PA- 294946

Product Advisory

PCB Component Footprint change

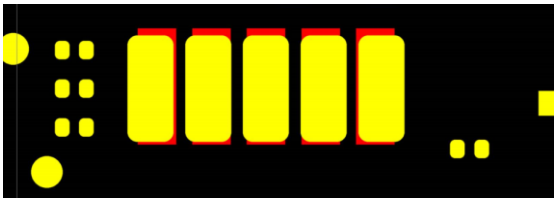
The 9560-16i/8i PCB was modified to increase the pad width for the power manager component.

This part is dual sourced and there are slight differences in each vendor's footprint. One vendor's part is more susceptible to being placed off the PCB pads causing resulting in potential manufacturing yield loss. To prevent this, the width of the pads was increased to accommodate both parts. The following picture shows minor changes in the pad width as shown in yellow. There were no other changes to the board.

There is no change to form, fit, or functionality.
